ADDENDUM NO. THREE

**ATHLETIC IMPROVEMENTS FOR
BRUNSWICK COUNTY SCHOOLS
(WBHS FIELDHOUSE)**

Date: **March 18, 2020**

Project No.: 1716 File: B-8.2

E101

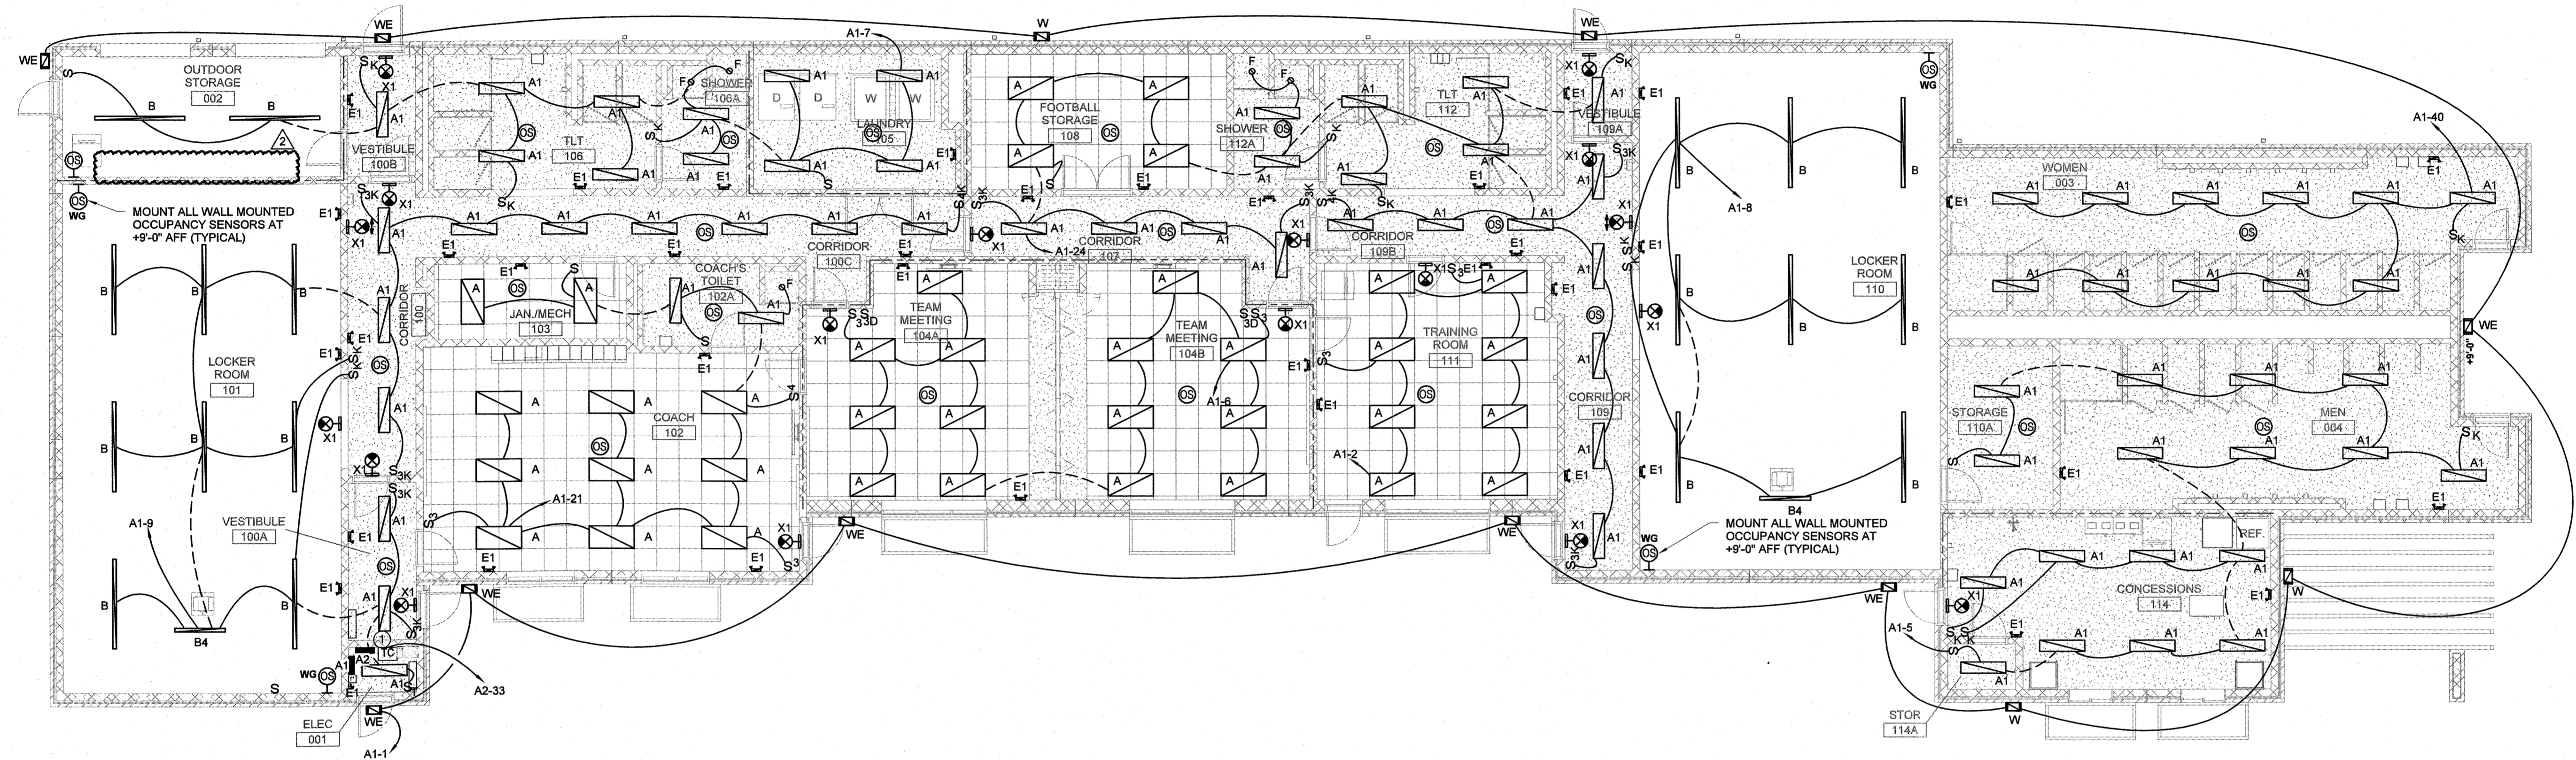
TC – (Time Clock) controls the exterior light circuit on Sheet E101

7. Sheet E101, rooms 003 & 004 do not have exit lights over the doors? Will those be needed? No Will those rooms require fire pull stations as well? No Please advise.

8. Sheet E101, next to panel A2 in the electrical room are two boxes drawn and marked [TC] and [LC]. Please clarify what these are. If [TC] is for time clock and [LC] is for lighting contractor, please advise on what the lighting contractor will be performing, amount of lights, types of lights, outputs on relays, etc. LC is not needed-TC controls circuit A1-1-the exterior lights.

Drawing E101

- Deleted two emergency fixtures from Outdoor Storage 002.

E201
SHEET

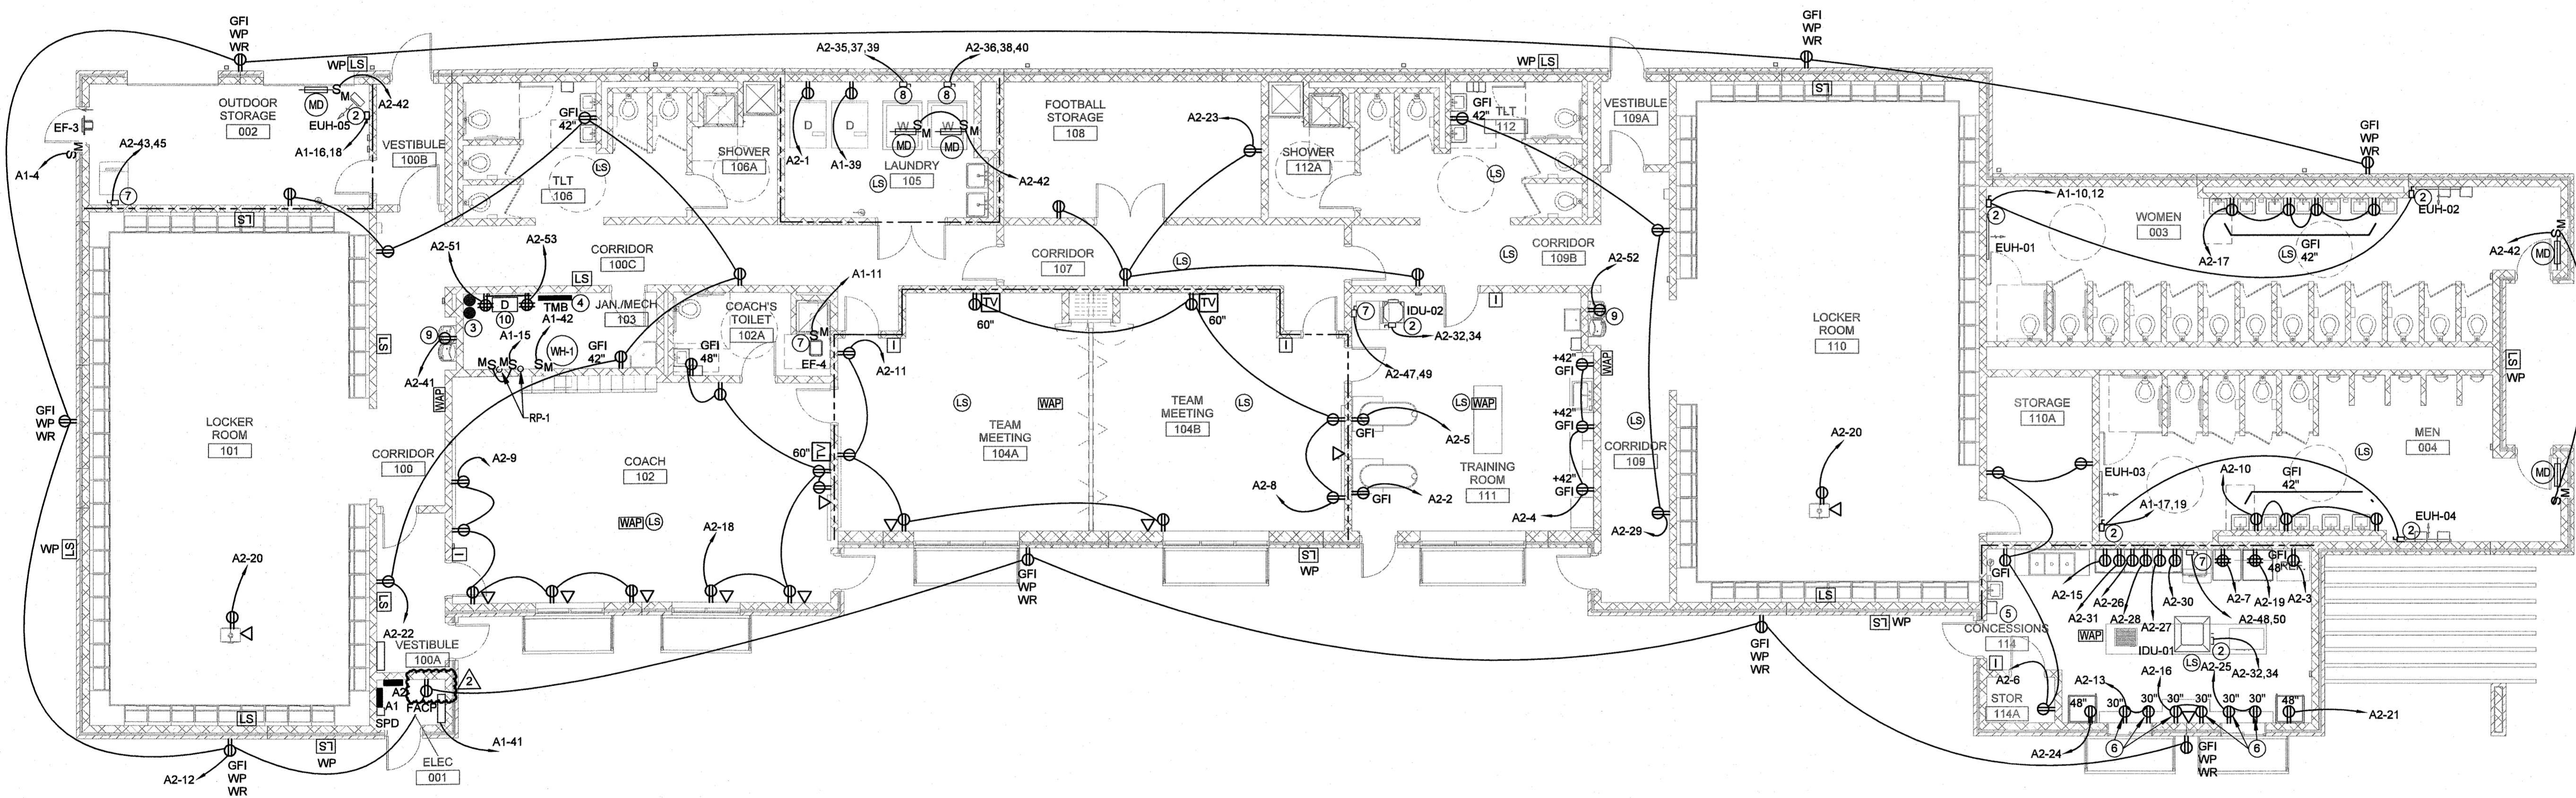
Drawing E201

- Added receptacle in Electrical Room 001.

E401

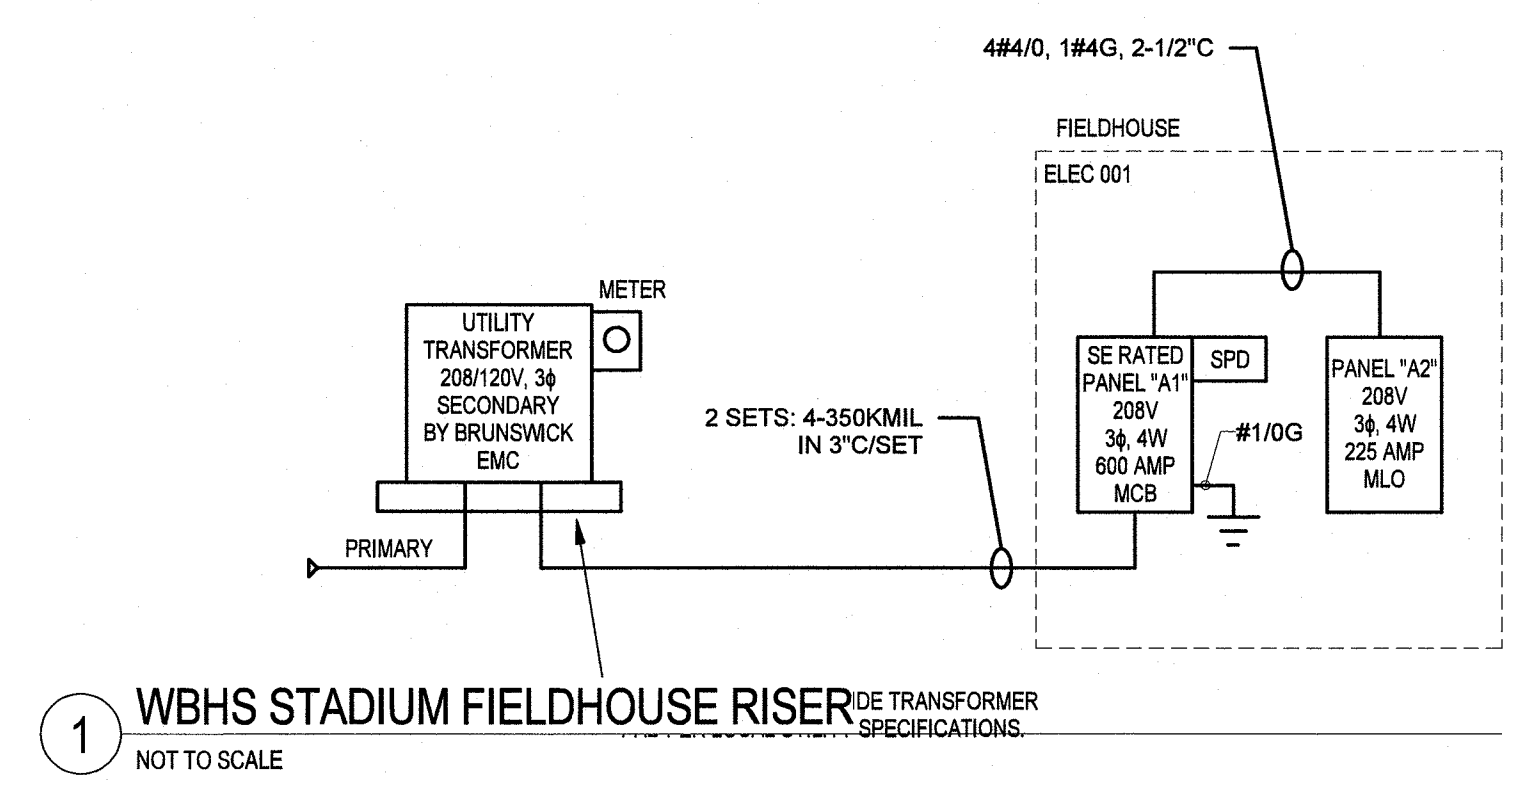
Drawing E401

- Panel Schedule changes.
